Rev.	Date	By	Ckd	Description
I	17/08/2023	WN	DN	S4.56 Issue 2

30 Fairlight St, Fairlight
30 Fairlight St,
Fairlight, NSW 2094

- SCHEDULE OF CHANGES**
1. Planter and deepsoil reduced to accommodate relocation of mailbox for DDA compliance.
 2. Amendment to location of carpark lobby doors
 3. OSD tank extended to accommodate minimum volume as per Stormwater Engineer's report.
 4. Additional door added for compliance as alternate fire egress with NCC D2D6.
 5. Landscaping and planter replaced with terrace hardscape to accommodate OSD tank volume below.
 6. Wall of front terrace rationalised for buildability
 7. Window opening reconfigured.
 8. Internal layout reconfigured and rationalised
 9. Plant services added onto roof including AC condensers, hot water units and mechanical vent exhausts to be concealed with metal screen enclosure
 10. PV panels added.
 11. Skylights deleted.
 12. Solid access hatch cover amended to glazed hatch.
 13. Courtyard landscape amendment.

DA203

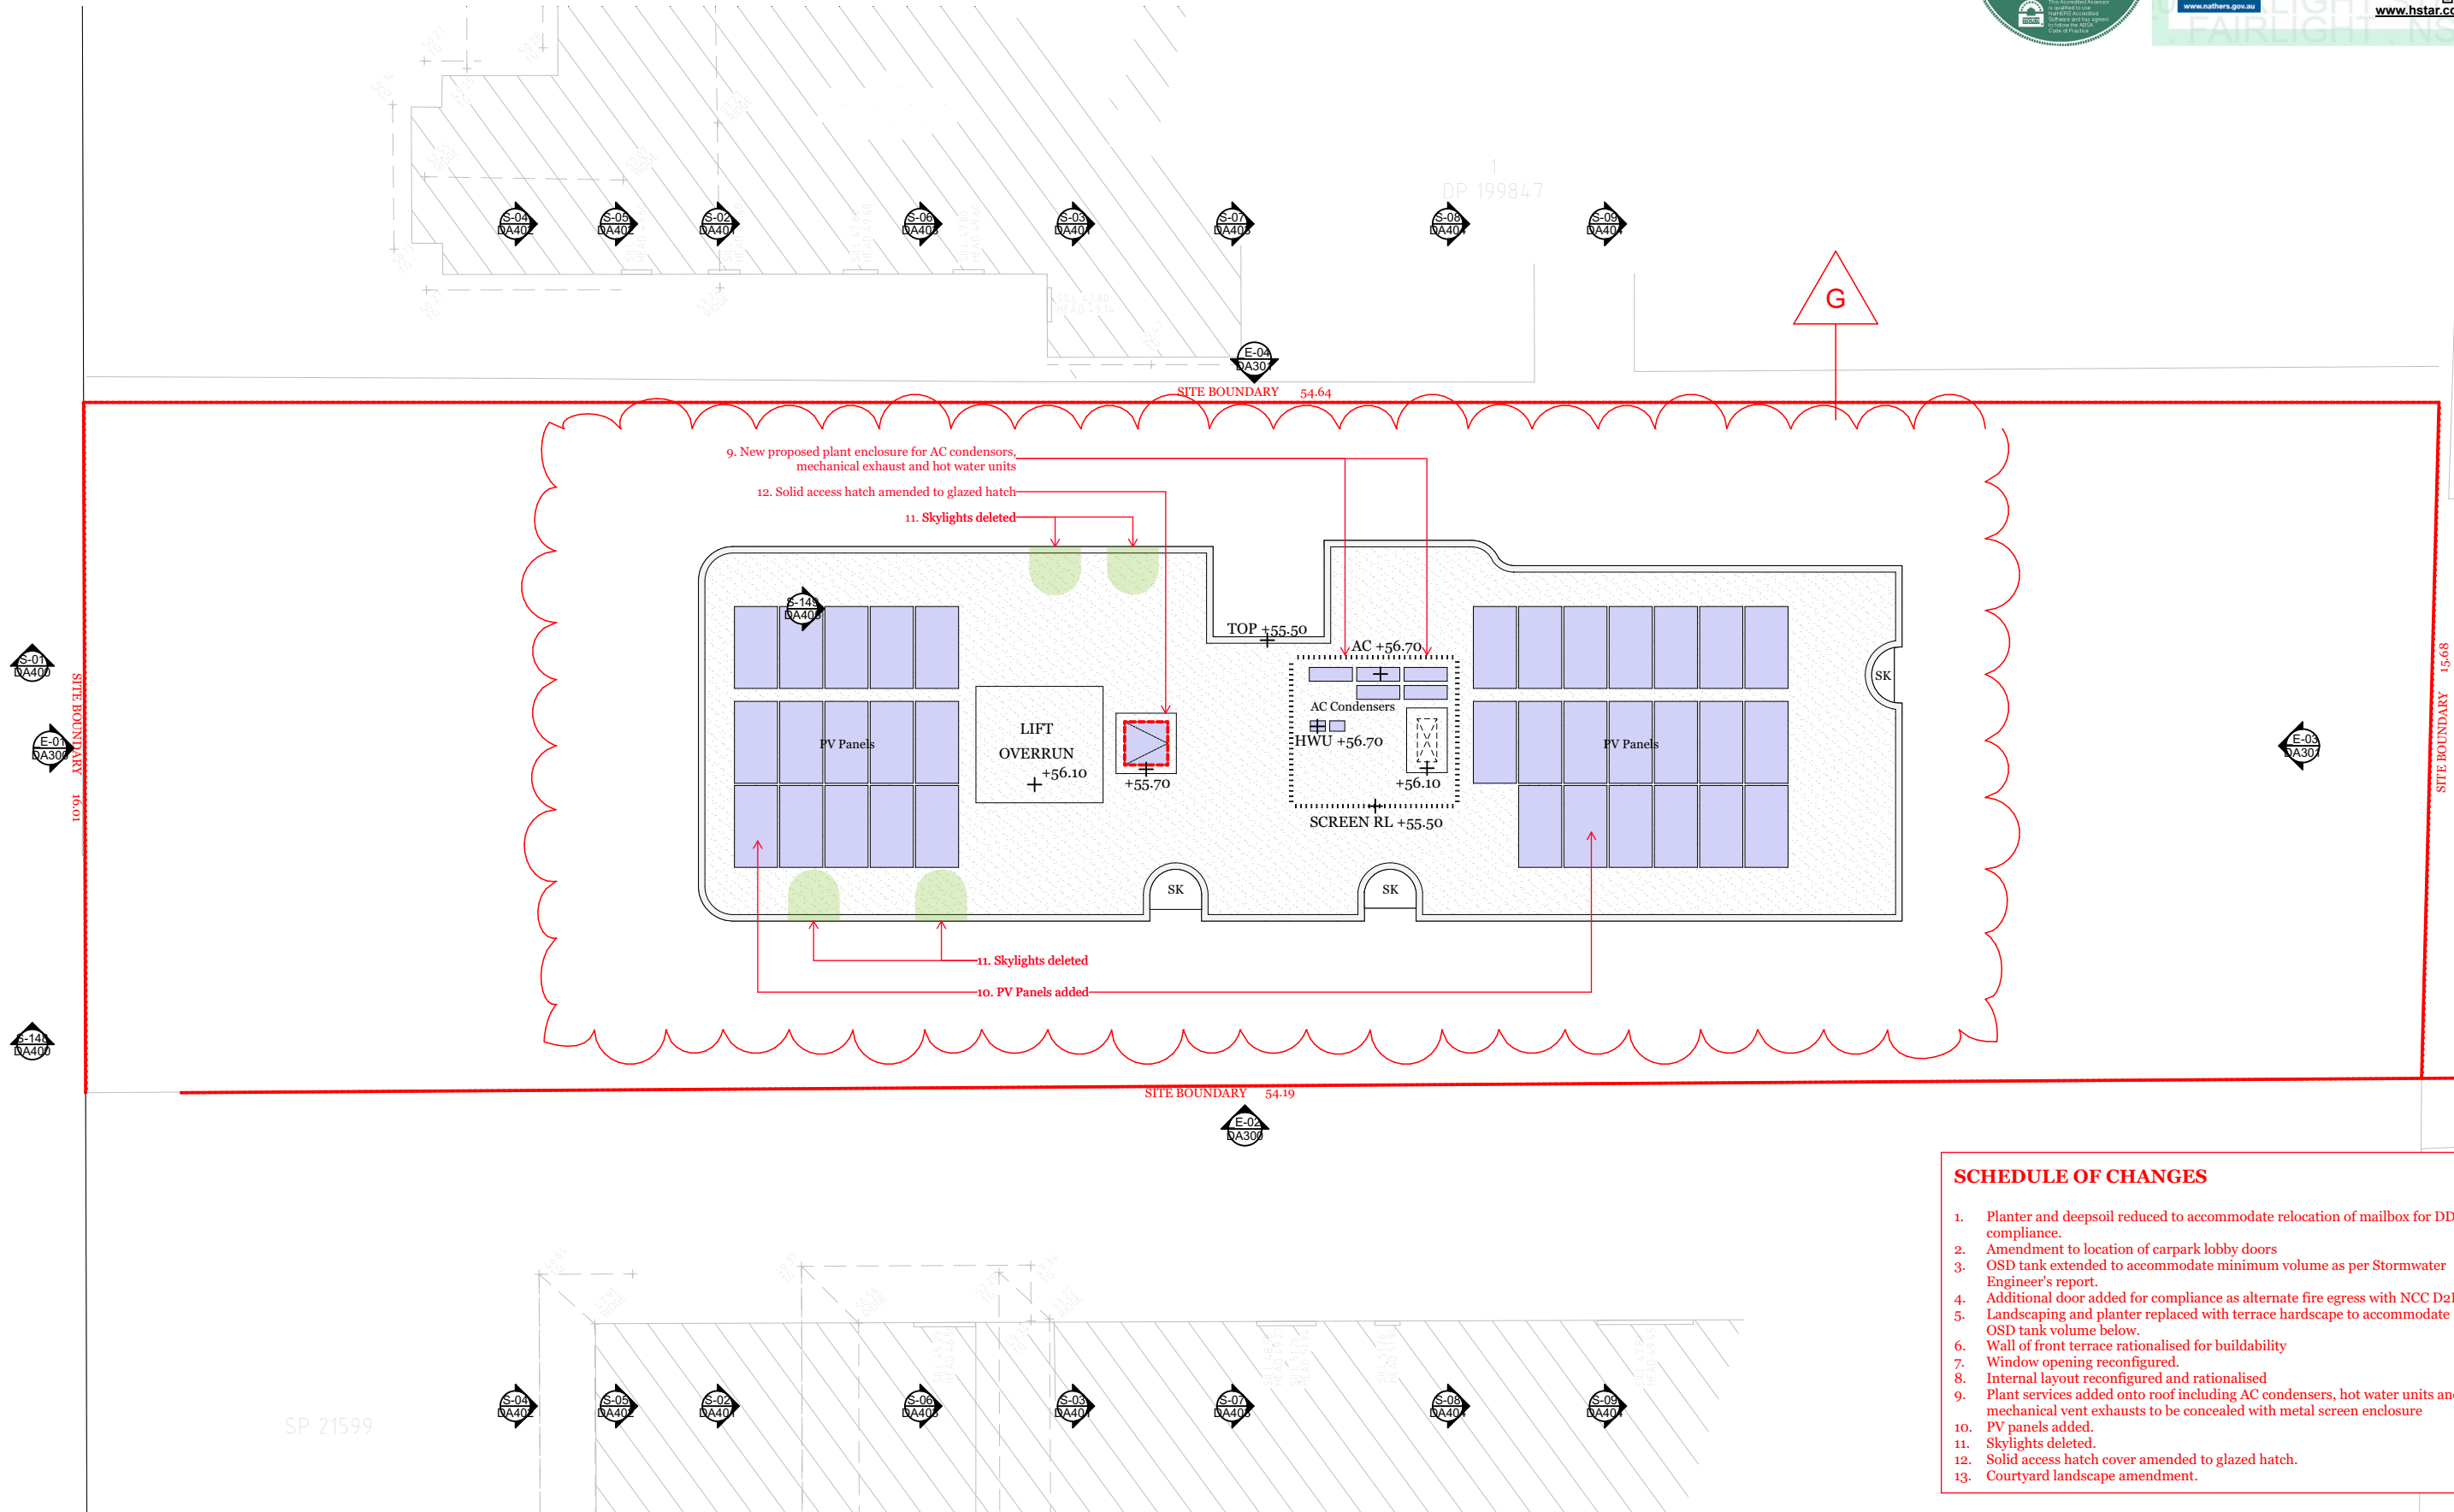
- SCHEDULE OF CHANGES**
- Planter and deepsoil reduced to accommodate relocation of mailbox for DDA compliance.
 - Amendment to location of carpark lobby doors
 - OSD tank extended to accommodate minimum volume as per Stormwater Engineer's report.
 - Additional door added for compliance as alternate fire egress with NCC D2D6.
 - Landscaping and planter replaced with terrace hardscape to accommodate OSD tank volume below.
 - Wall of front terrace rationalised for buildability
 - Window opening reconfigured.
 - Internal layout reconfigured and rationalised
 - Plant services added onto roof including AC condensers, hot water units and mechanical vent exhausts to be concealed with metal screen enclosure
 - PV panels added.
 - Skylights deleted.
 - Solid access hatch cover amended to glazed hatch.
 - Courtyard landscape amendment.

South-Facing Elevation

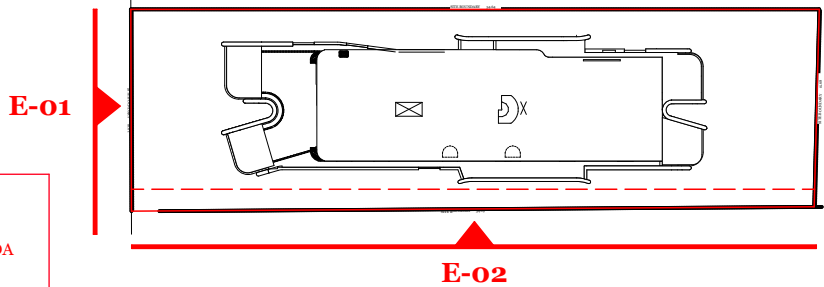
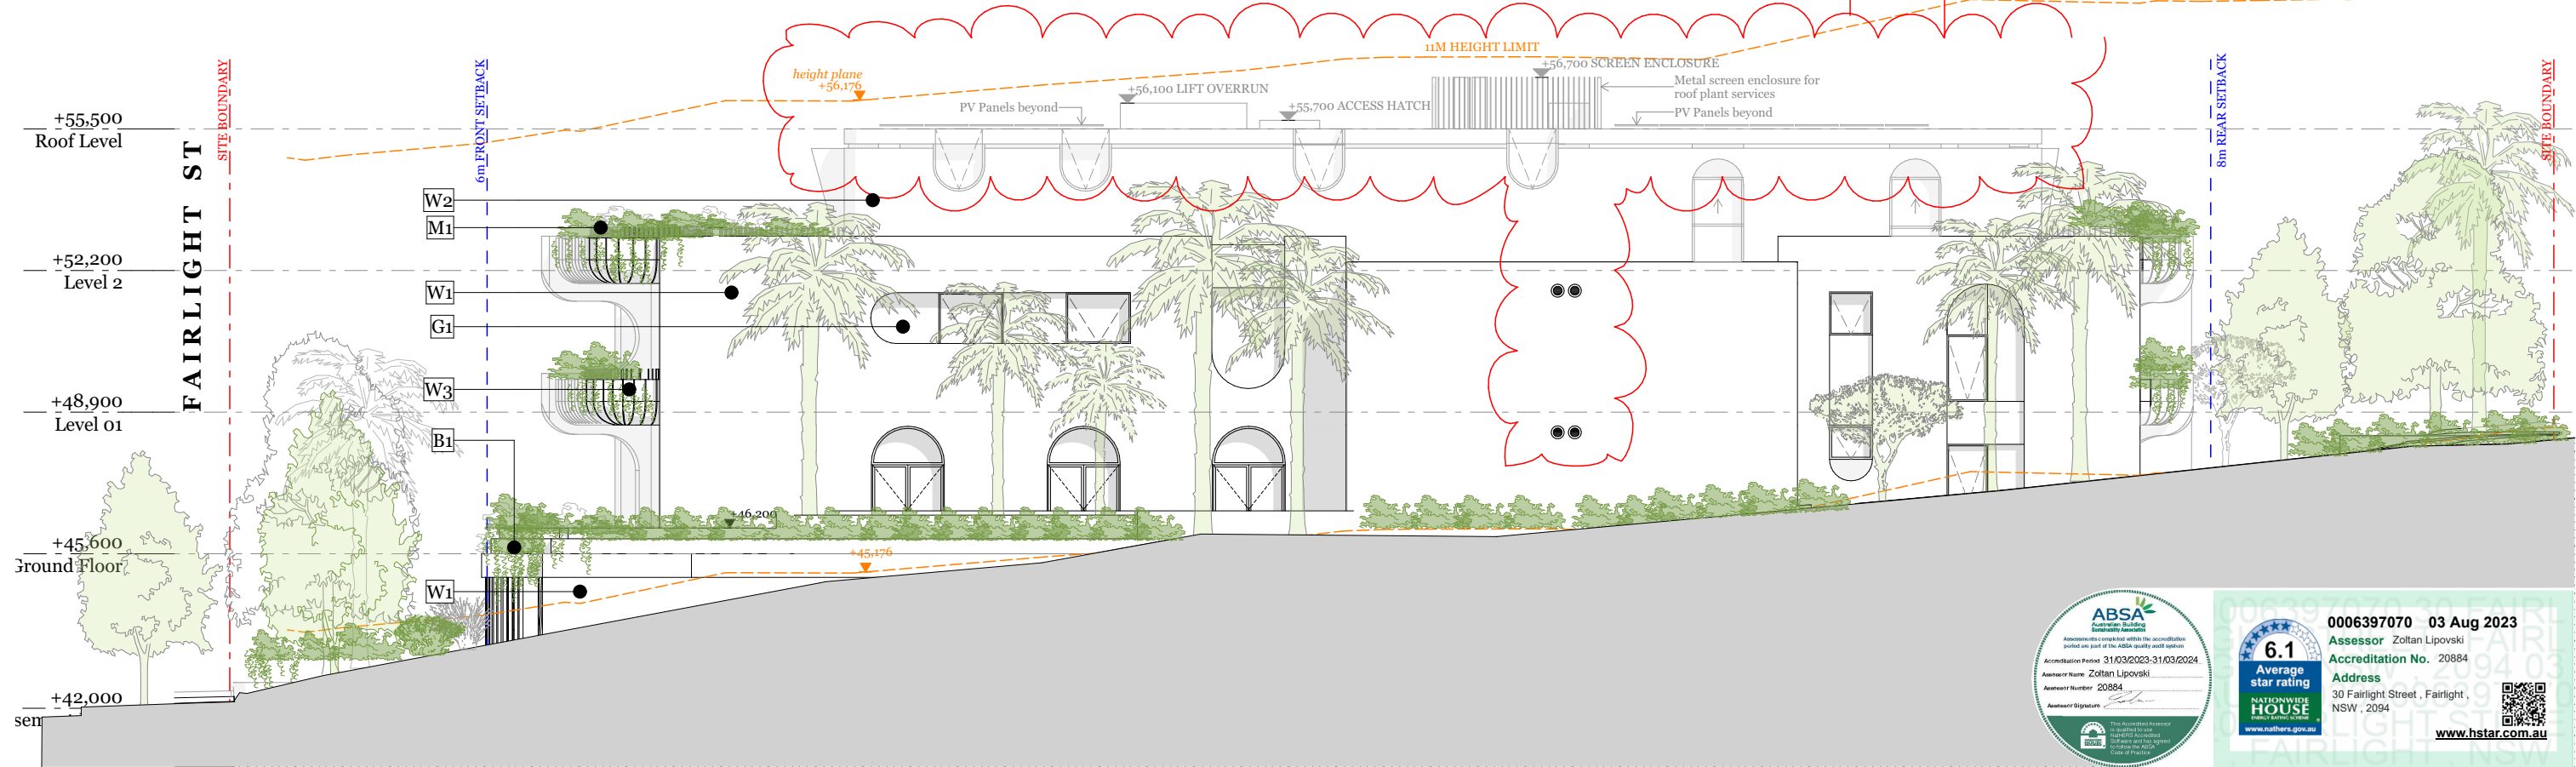
- SCHEDULE OF CHANGES**
1. Planter and deepsoil reduced to accommodate relocation of mailbox for DDA compliance.
 2. Amendment to location of carpark lobby doors
 3. OSD tank extended to accommodate minimum volume as per Stormwater Engineer's report.
 4. Additional door added for compliance as alternate fire egress with NCC D2D6.
 5. Landscaping and planter replaced with terrace hardscape to accommodate OSD tank volume below.
 6. Wall of front terrace rationalised for buildability
 7. Window opening reconfigured.
 8. Internal layout reconfigured and rationalised
 9. Plant services added onto roof including AC condensers, hot water units and mechanical vent exhausts to be concealed with metal screen enclosure
 10. PV panels added.
 11. Skylights deleted.
 12. Solid access hatch cover amended to glazed hatch.
 13. Courtyard landscape amendment.

Section - S-01

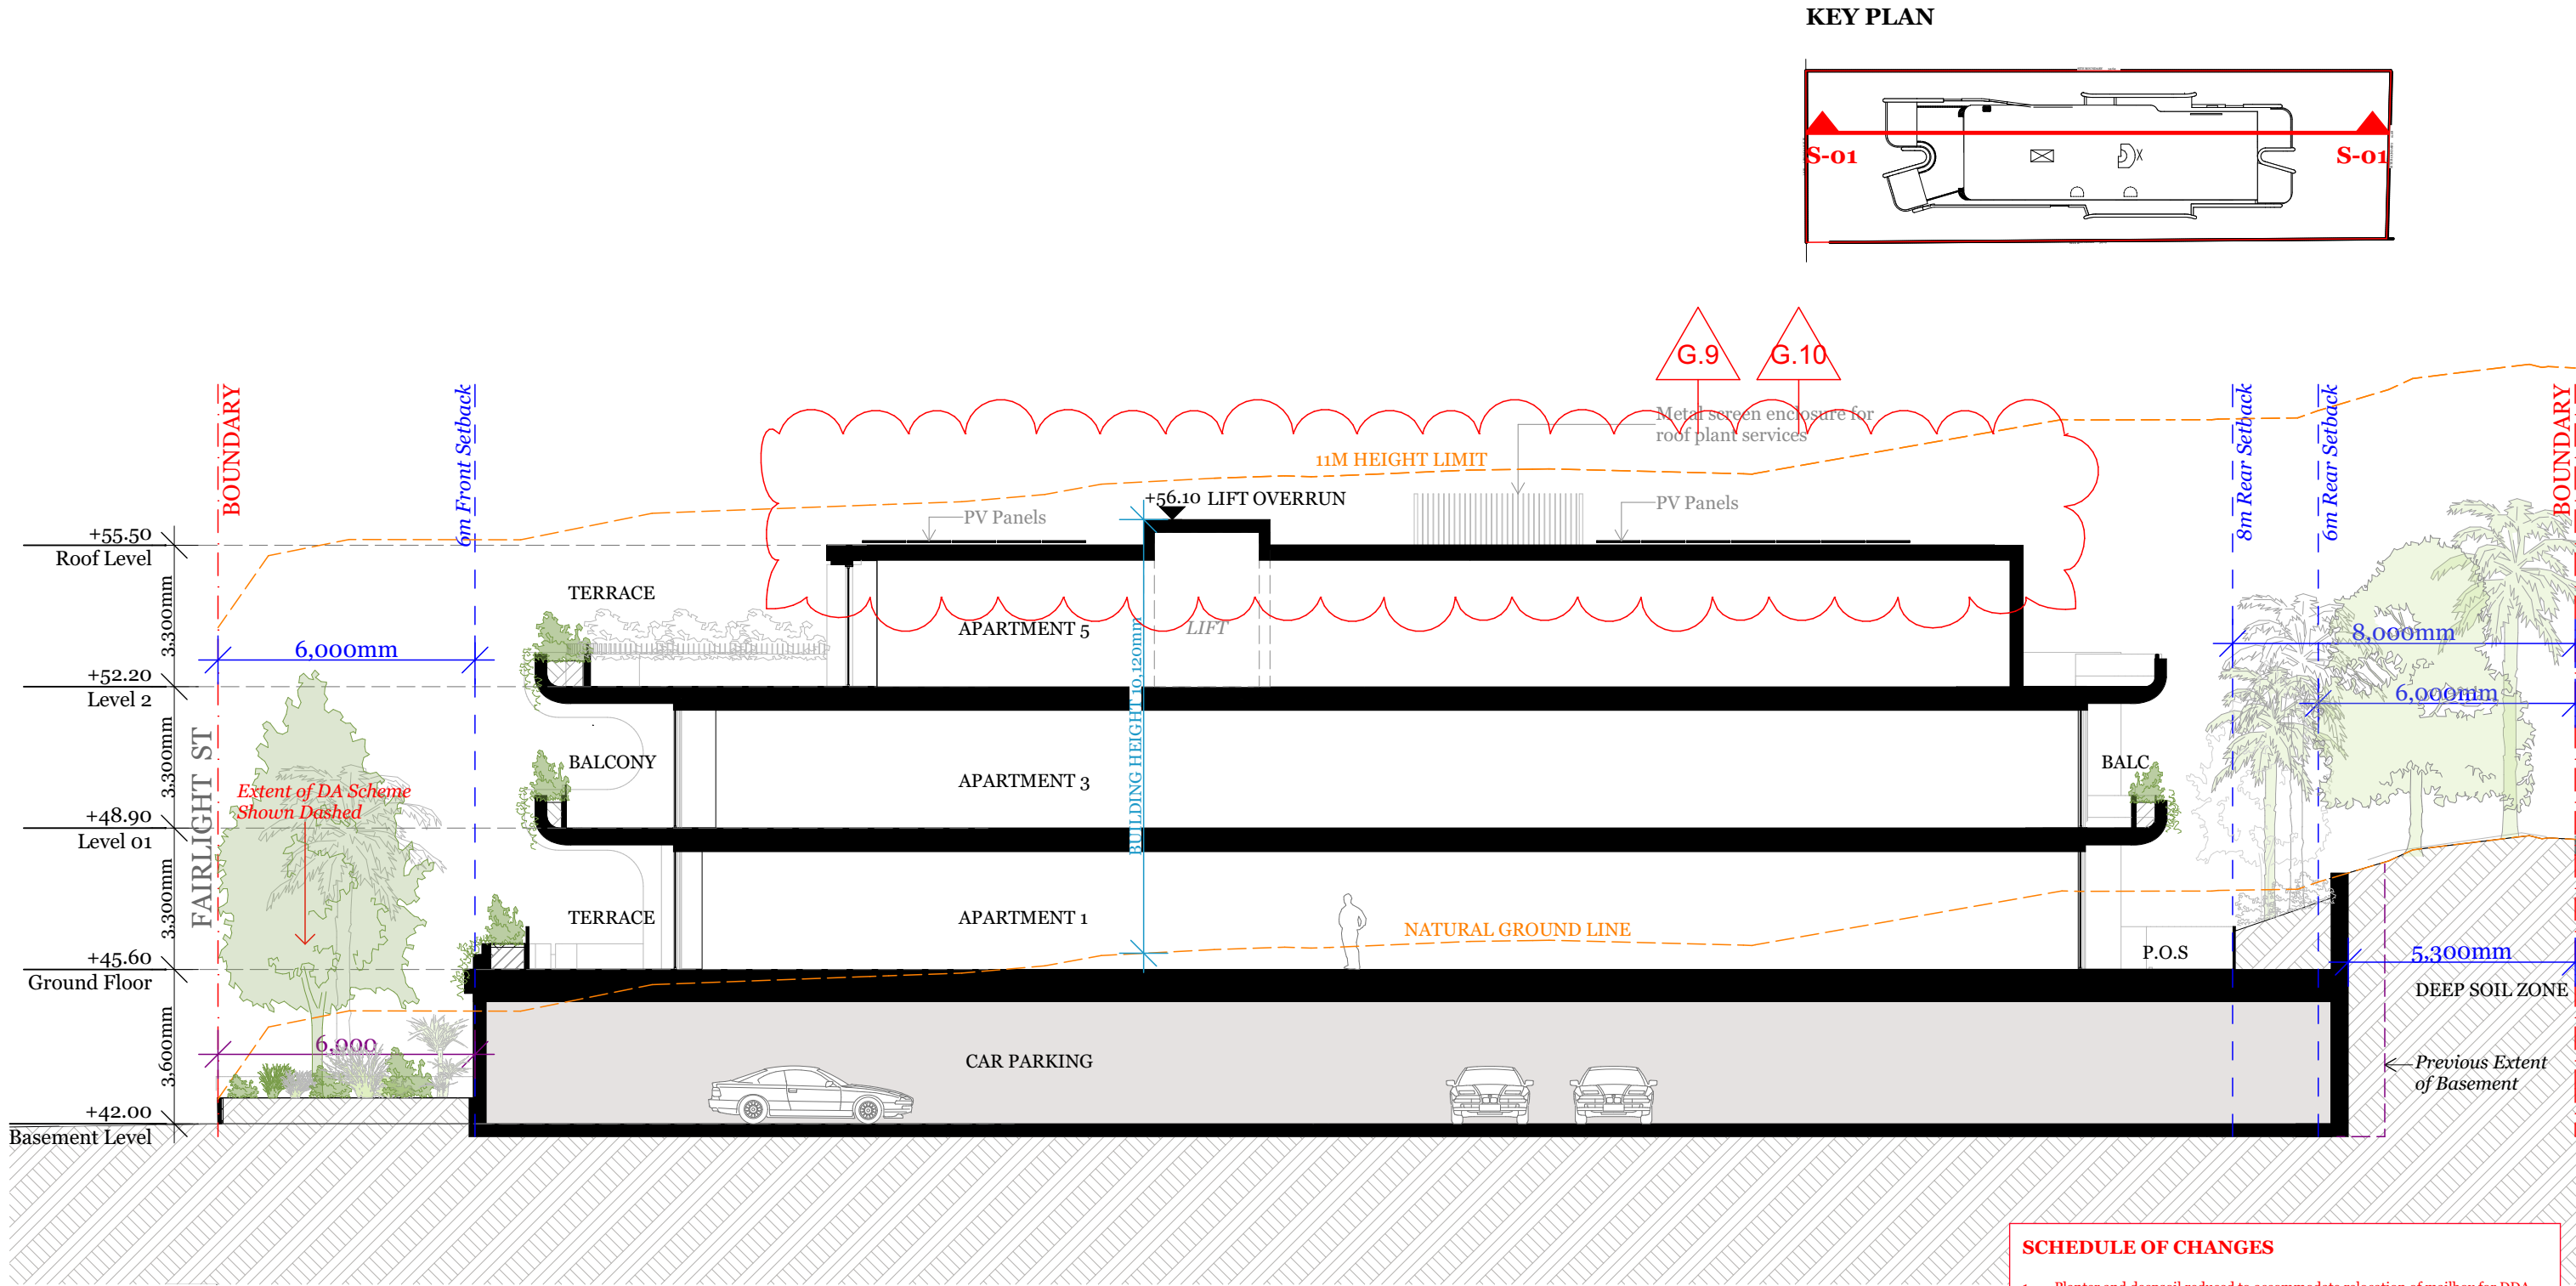
1. Planter and deepsoil reduced to accommodate relocation of mailbox for DDA compliance.
2. Amendment to location of carpark lobby doors
3. OSD tank extended to accommodate minimum volume as per Stormwater Engineer's report.
4. Additional door added for compliance as alternate fire egress with NCC D2D6.
5. Landscaping and planter replaced with terrace hardscape to accommodate OSD tank volume below.
6. Wall of front terrace rationalised for buildability
7. Window opening reconfigured.
8. Internal layout reconfigured and rationalised
9. Plant services added onto roof including AC condensers, hot water units and mechanical vent exhausts to be concealed with metal screen enclosure
10. PV panels added.
11. Skylights deleted.
12. Solid access hatch cover amended to glazed hatch.
13. Courtyard landscape amendment.
